METROPOLITAN GOVERNMENT OF NASHVILLE AND DAVIDSON COUNTY

STAFF RECOMMENDATION
1011 Clearview Avenue
October 17, 2012

Application: New construction-addition
District: Lockeland Springs-East End Neighborhood Conservation Zoning Overlay
Council District: 06
Map and Parcel Number: 08309013800
Applicant: Robin Zeigler
Project Lead: Robin Zeigler, robin.zeigler@nashville.gov

Proposed Site Plan 1" = 2' 4"
1/8" = 1'-0"

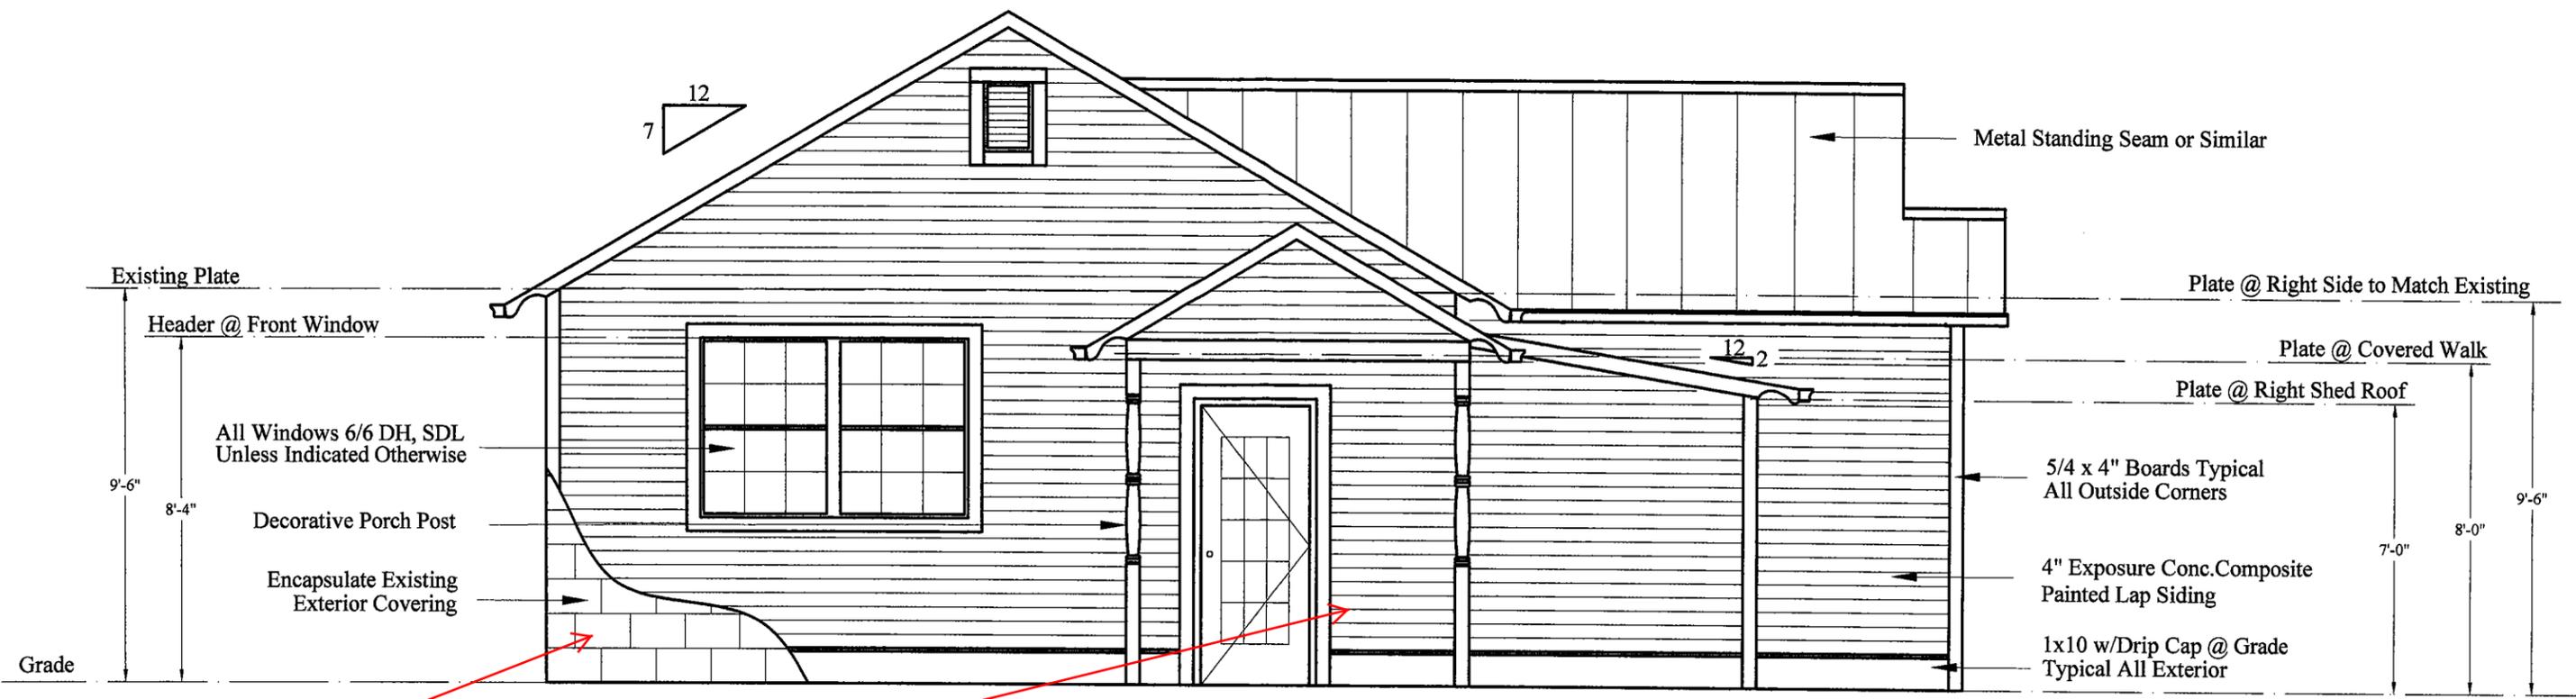
Addition should begin no closer than this point.

Addition of front porch is removed from request.

Front
 $\frac{1}{4}'' = 1'-0''$

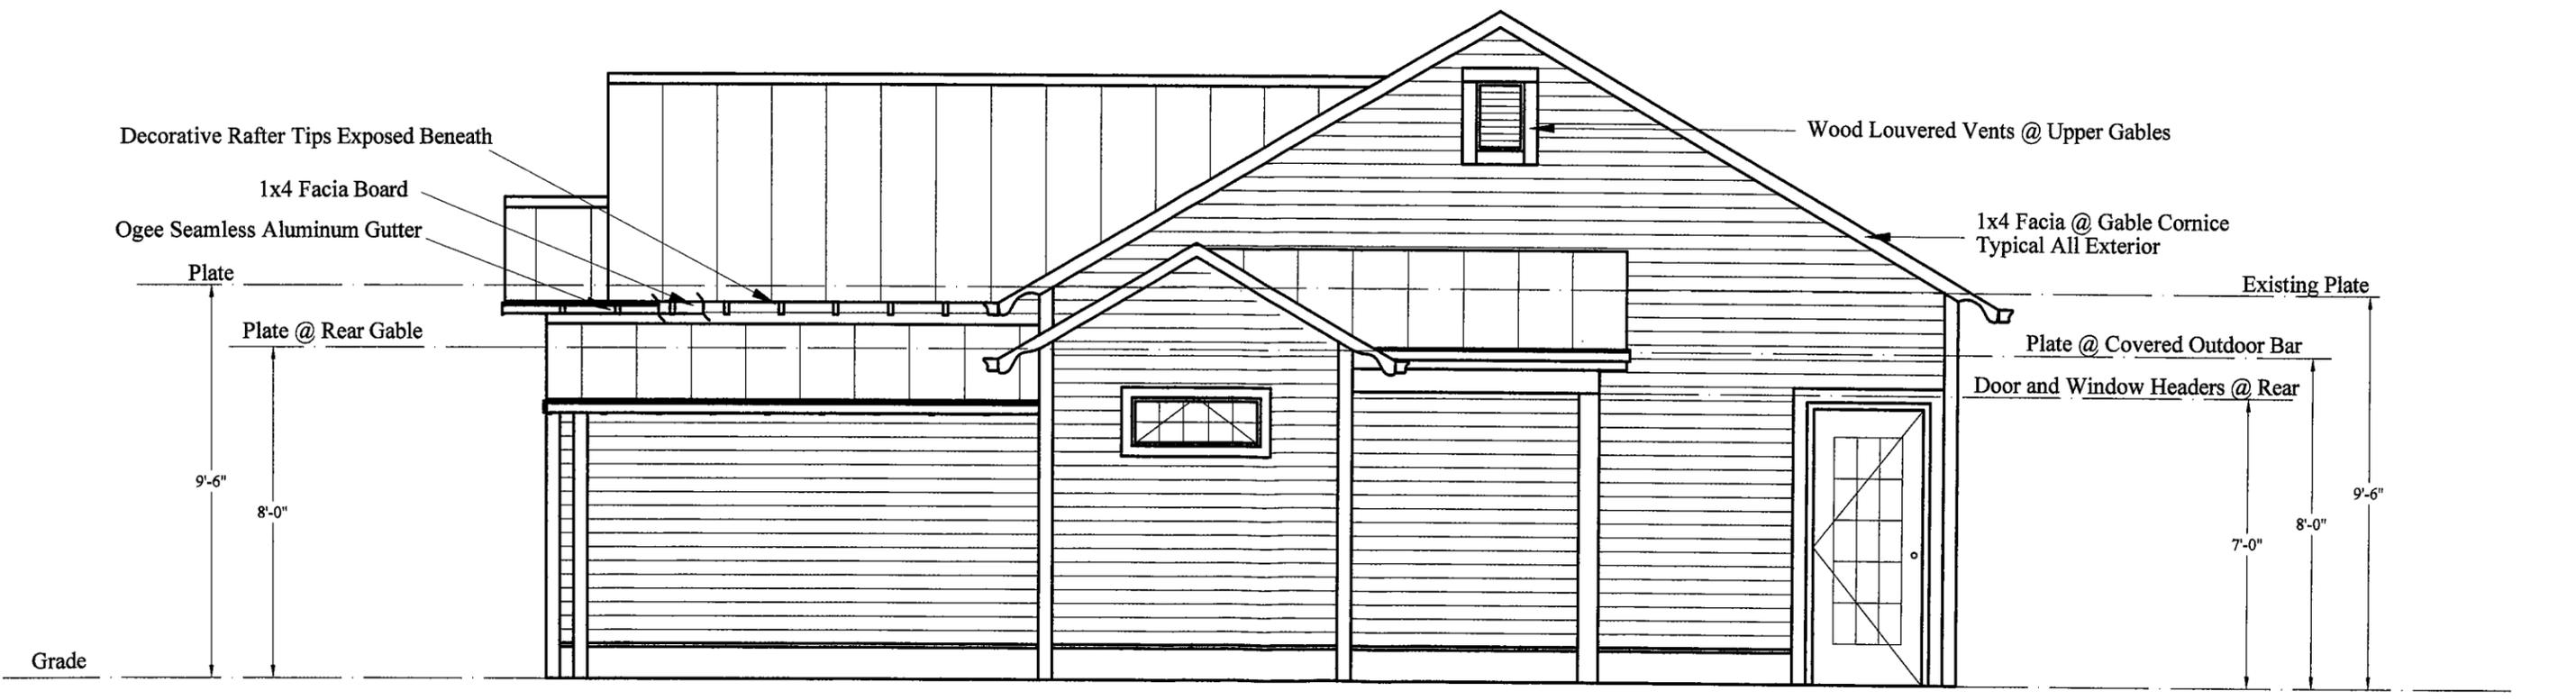
Existing materials are non-historic or compromised. Replacement is appropriate.

Rear
 $\frac{1}{4}'' = 1'-0''$

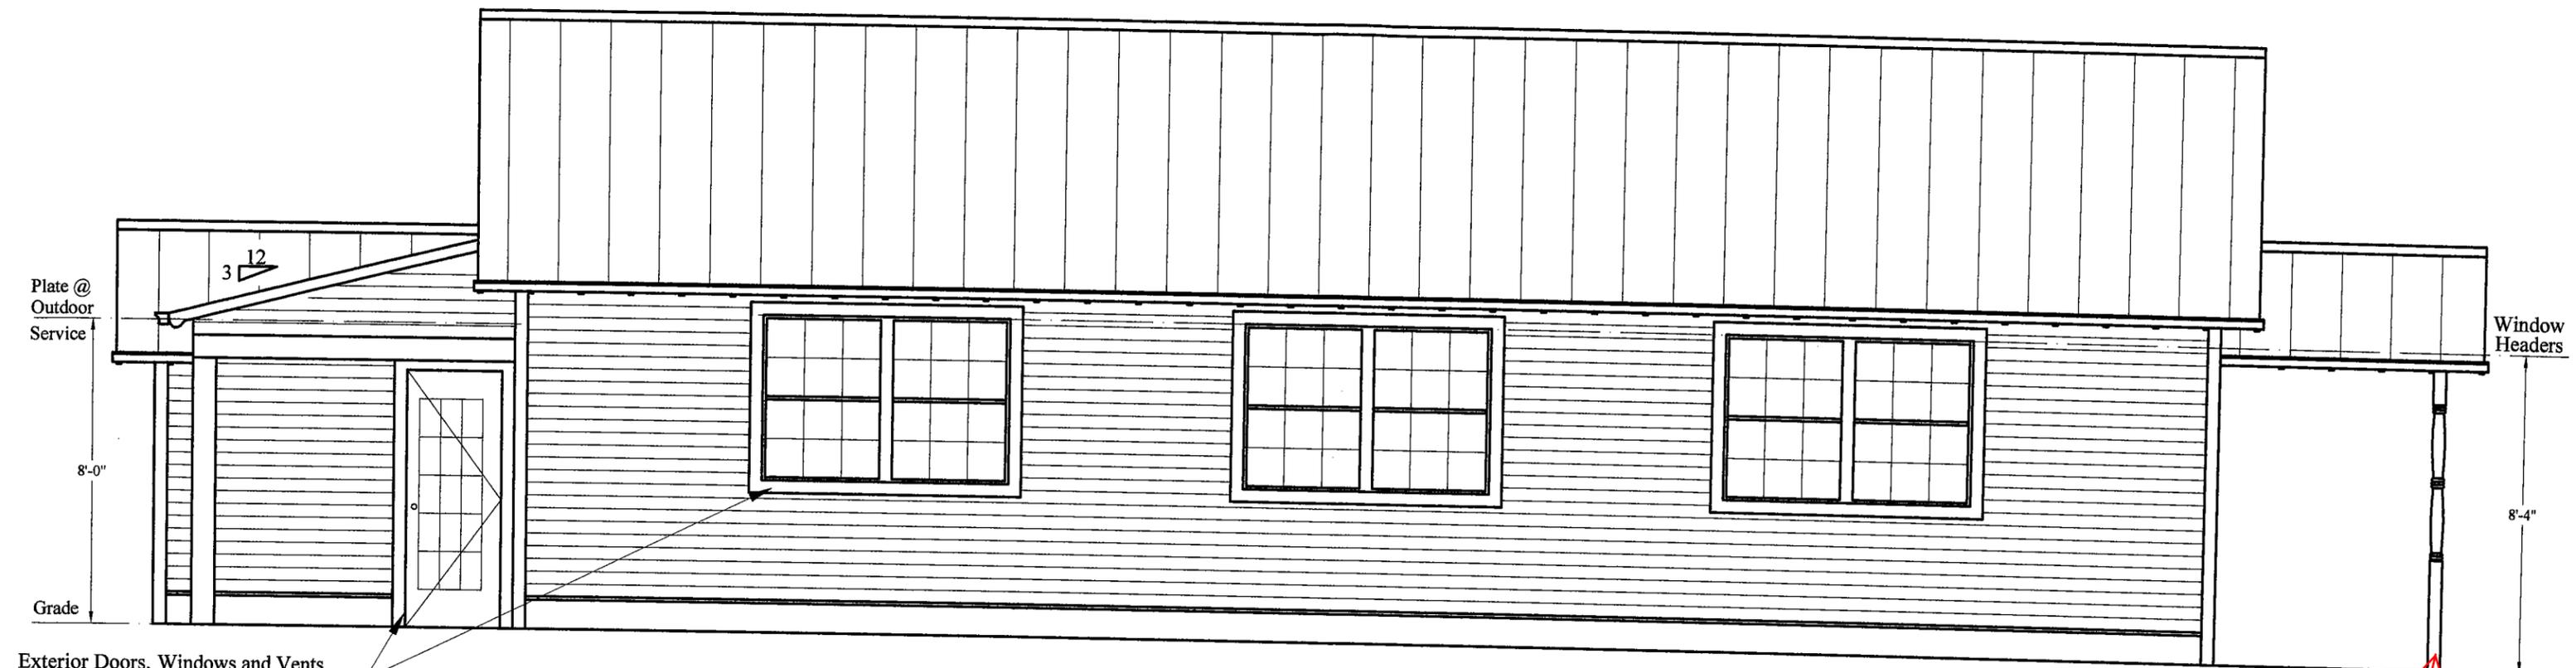
Addition of front porch is removed from request.

Left 1' 2' 4'
 $\frac{1}{4}'' = 1'-0''$

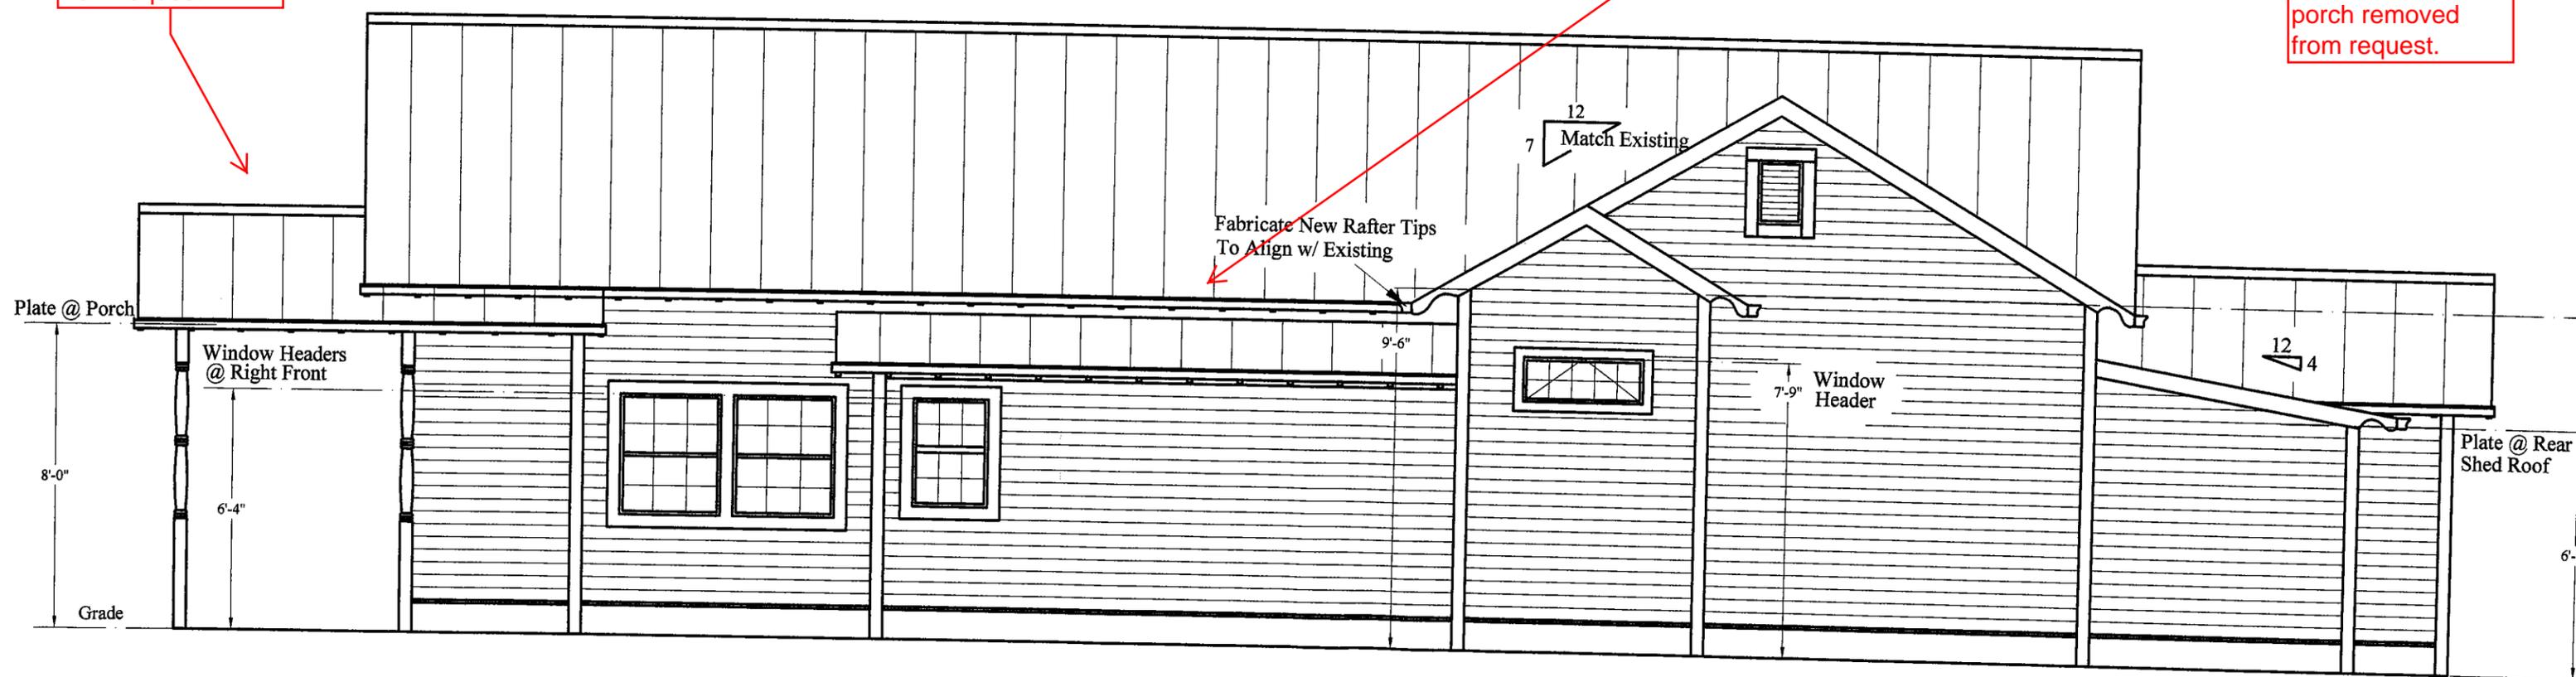
Addition of front porch is removed from request.

Addition should sit back.
